Station

TRIENNALE VELOCITA' S.P.A.
 AREA CENTRO SUD
 STAZIONE AV. DI FRESCHE

PROGETTO DEFINITIVO

Stazione AV
 Setting Out dell'Elemento di Investimento della Copertura
 Tipo 01 e 02 (UD)

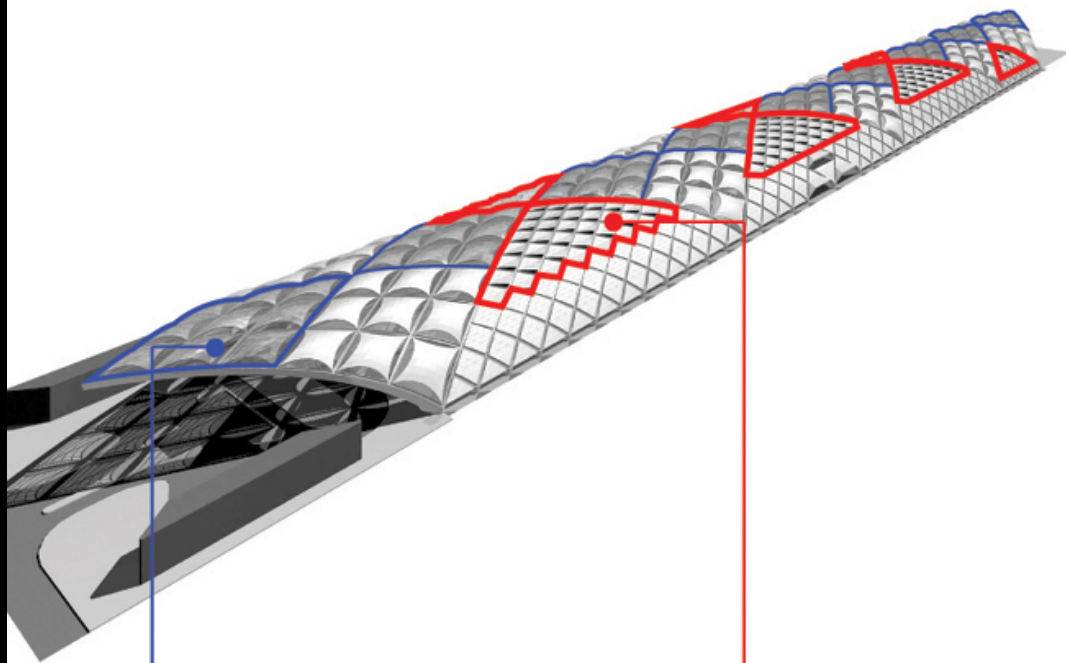
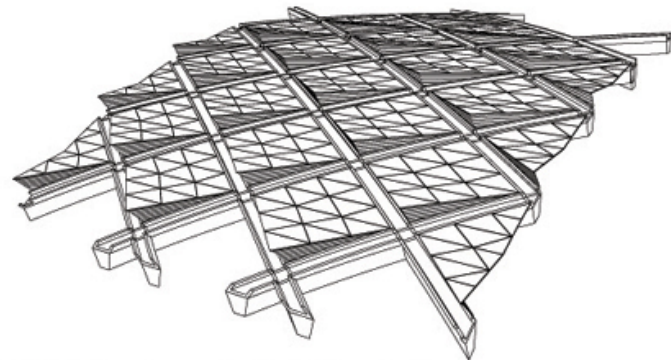
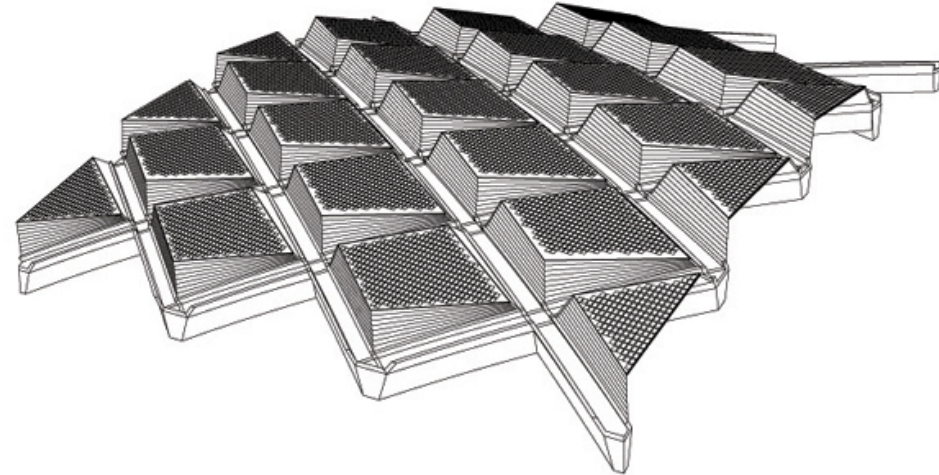
In Definitivo PV panels were located in the RCU-01 units (top 3x3 pillow bays).

In the current issue PV panels are located in the RCU-03 units (vents area).
